### **REMARKS**

APPLICATION No. 09/737,402  
AMENDMENT DATED SEPT. 29, 2004  
REPLY TO OFFICE ACTION OF JUNE 29, 2004  
ANNOTATED SHEET SHOWING CHANGES (SHEET 1/4)

# FIGURE 1

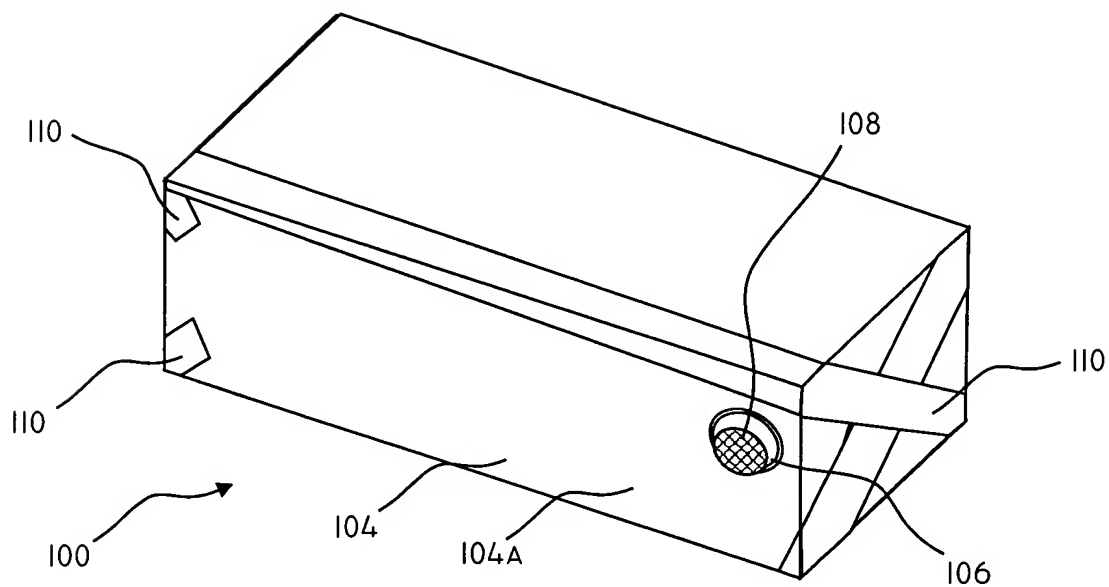
In the present Office Action, the Examiner objected to the drawings as failing to show every feature of the invention specified in the claims.

New Figure 1 provides an illustration of the casket shield of the present invention as placed around a casket, and depicts the ventilation port, screen, and tape. A clean copy of New Figure 1 is provided in Exhibit A, while an Annotated Sheet Showing Changes has been provided in Exhibit B.

*New Figure, showing elements  
of the described invention.*

## FIGURE 2A

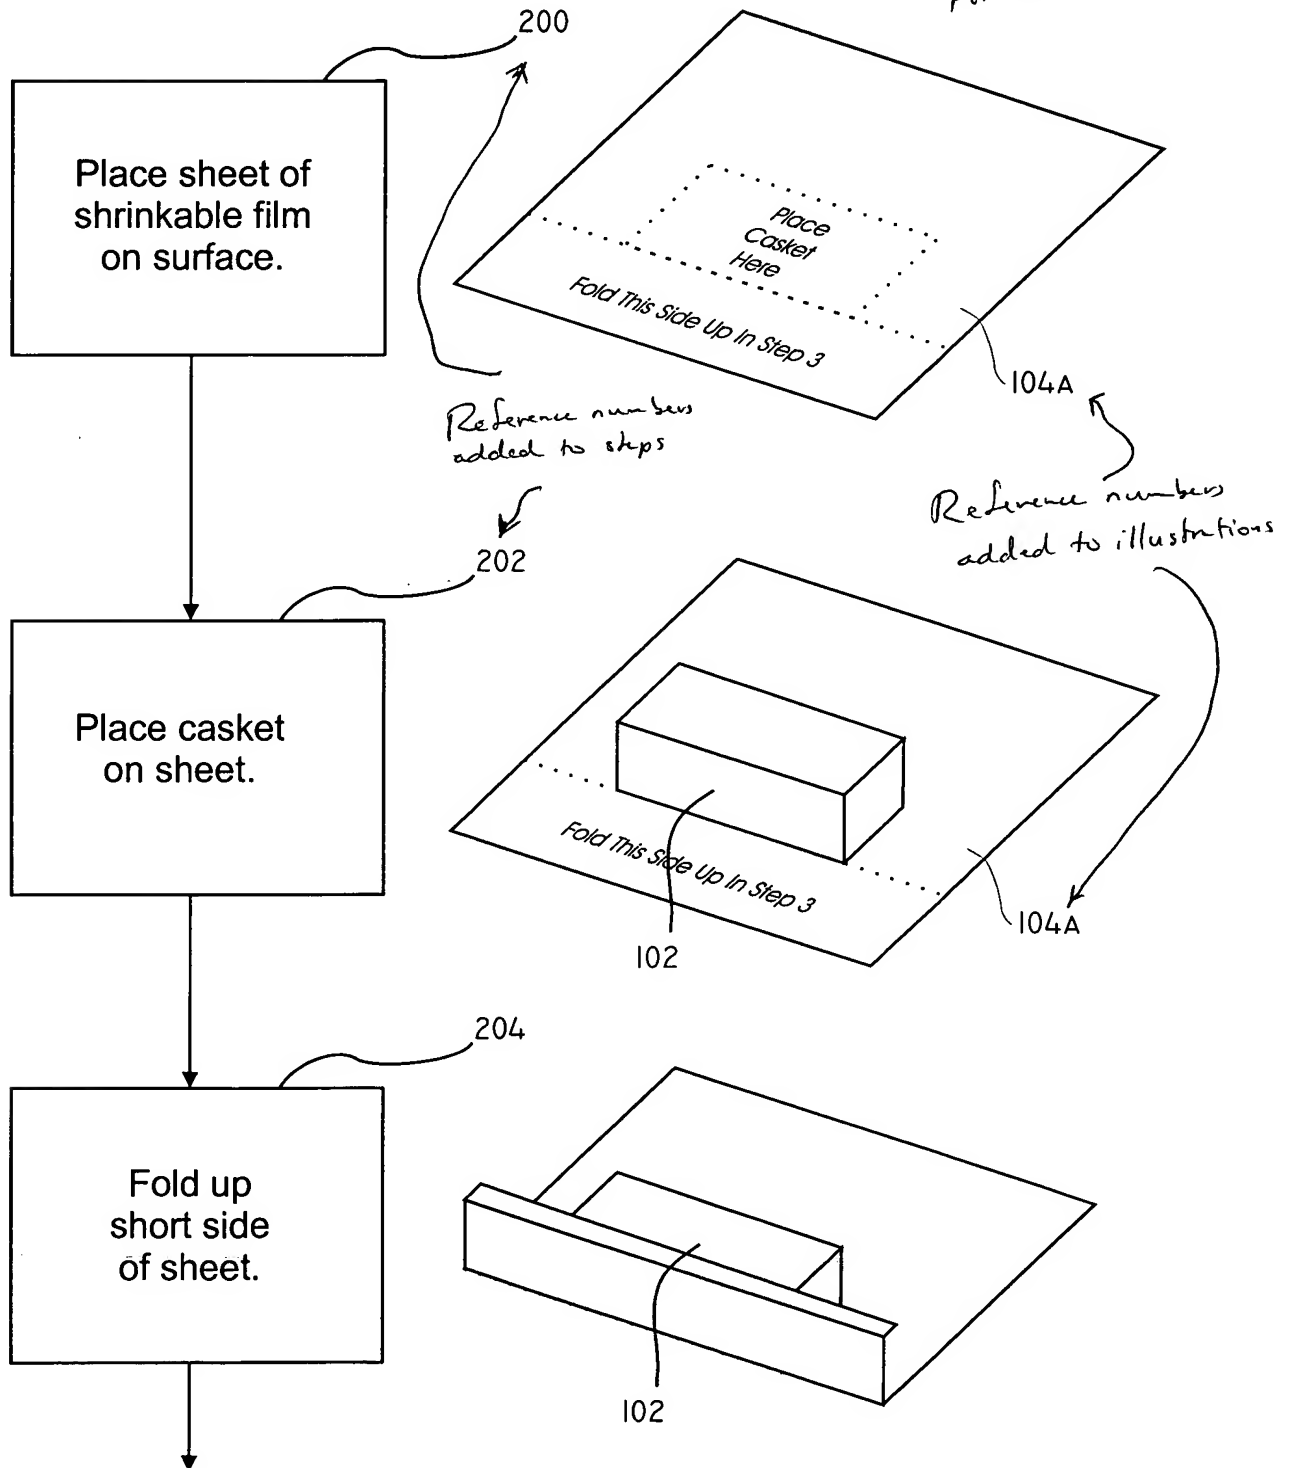
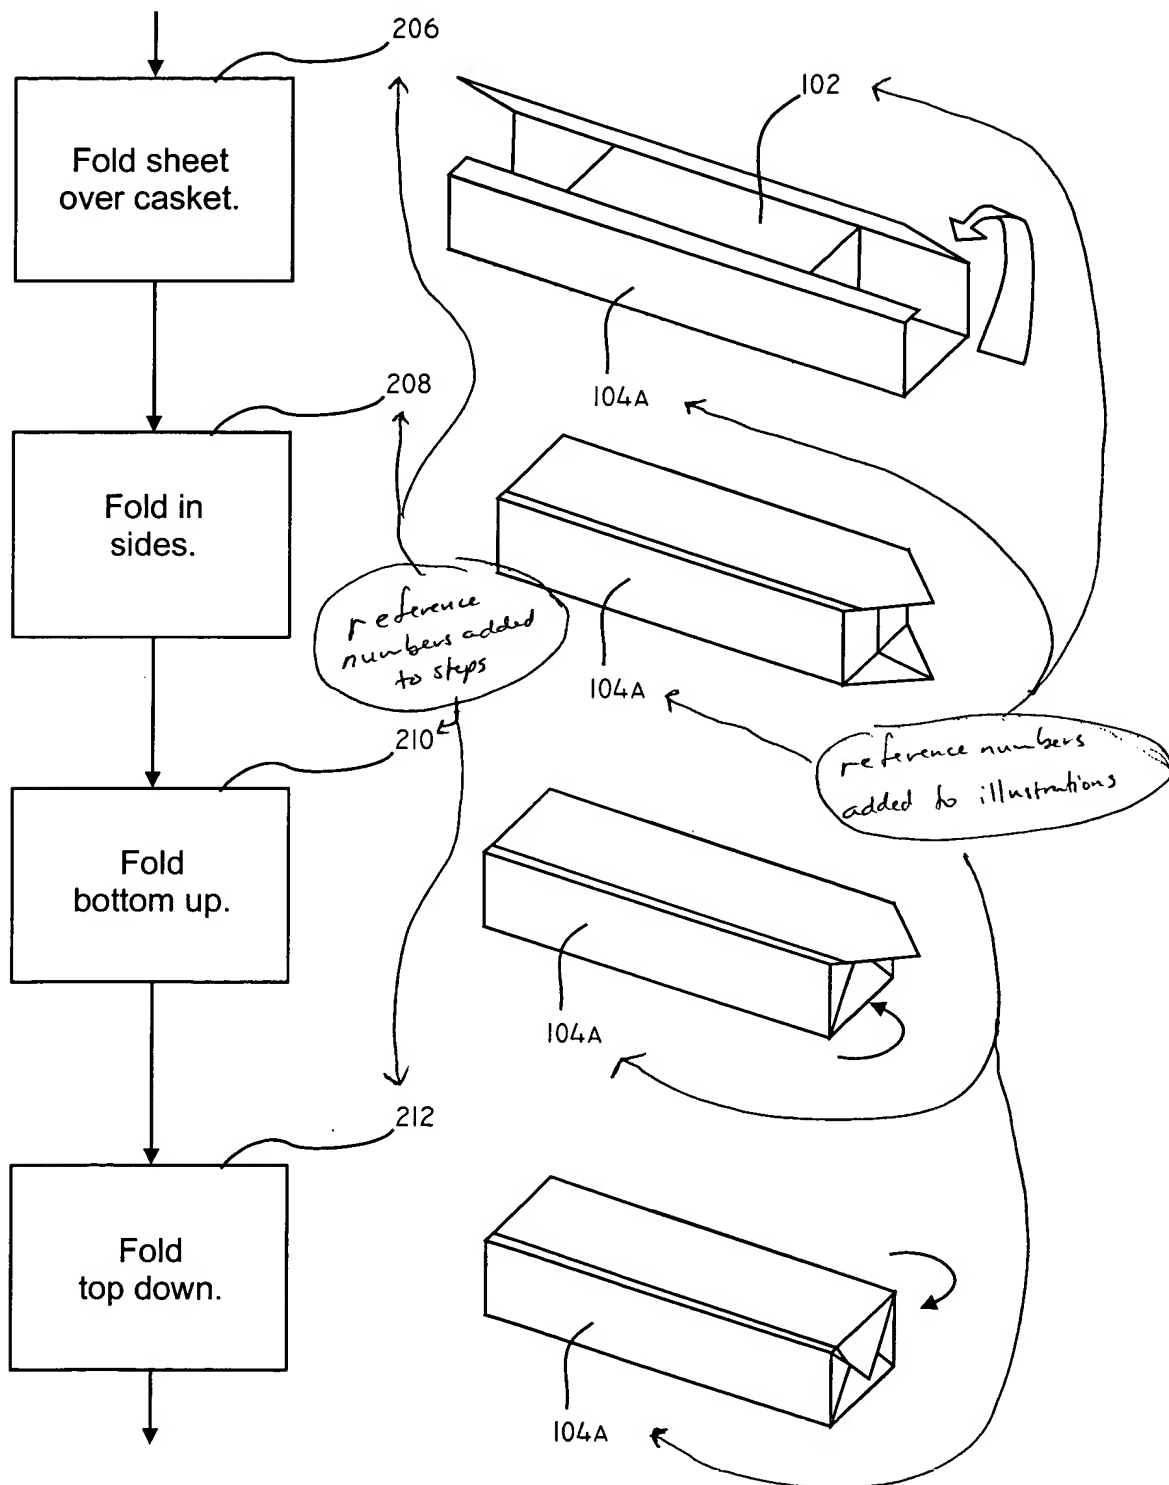
New Figure 2 corresponds to previously submitted Figure 1, however has been amended to provide flow diagram formatting illustrating the organization of the steps, as well as reference numerals for the steps and elements illustrated in the Figure. Furthermore, original Figure 1 extended across two pages, while new Figure 2 extends across three pages (sheets 2-4).

Previously Figure  
1, with prior steps  
placed in flow chart  
format.
